MUNCIE POWER PRODUCTS

## Product Bulletin #00116

### **Subject: ASCS-106 Combo Kit Air Console**

Date: August 23, 2023

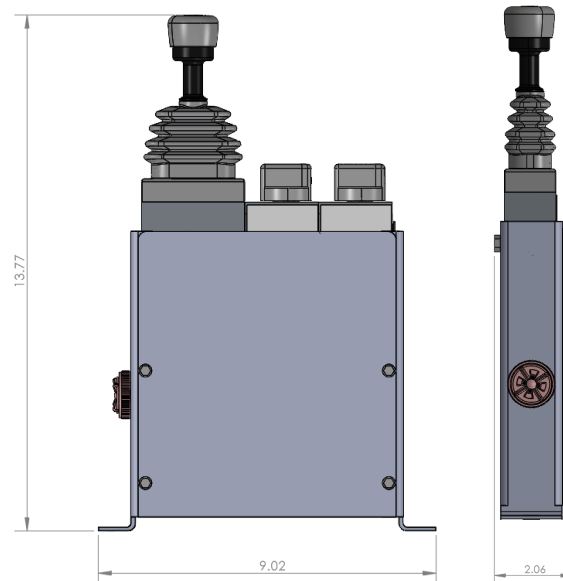
The ASCS-106 is the new Combo Kit air console replacing the ASCS-105. The old air valve, 35T35898P1, used in the ASCS-105 has been discontinued, making it and the ASCS-105 obsolete. Remaining service parts for the ASCS-105 will be available until inventory is depleted.

The new air valve, 35T67071, looks the same with some minor differences. It functions the same and it installs the same as the old valve. **Note:** The 35T67071 will not fit in the old console housing.

The difference is the PTO and auxiliary valve sections. They are each a little wider requiring a new wider console housing. The new ASCS-106 console assembly overall is 0.65" wider at 9.02" and is 0.47" taller at 13.77". The depth or thickness remains the same.

One advantage of the new valve is that the PTO and auxiliary valve sections can be added, removed, or rearranged as needed without special length bolts and port plugs.
